Flagship Chain Differences

Elevator Chain Service Parts

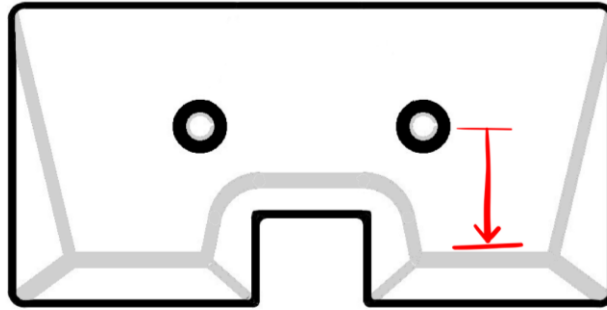
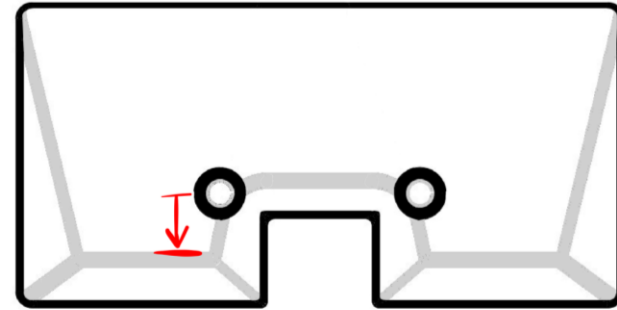
751240 CHAIN NOTES

- Started Shipping in year 2020
- Heavy duty (HD) - taller/HD 3 pitch sections on entire chain
- Less prone to breaking paddles
- Bolt hole in middle of paddle

ALL PRIOR CHAINS

- Part #s: 750838, 751210, 750237, 750638, 750520
 - Most had standard paddles + HD property bucket
 - Some may not have HD property bucket
 - Some may have HD crud brush
- visually inspect to ID replacement style needed

- Can't put old style paddles on new style chain and vice versa - bolt holes don't line up.

UNLESS you also replace the 3 pitch section.

- Example: has old crud brush 750611 in stock and wants to put on new 751240 chain. Would need old 750239 3 pitch to make that work.
(usually easier to order the correct paddle)
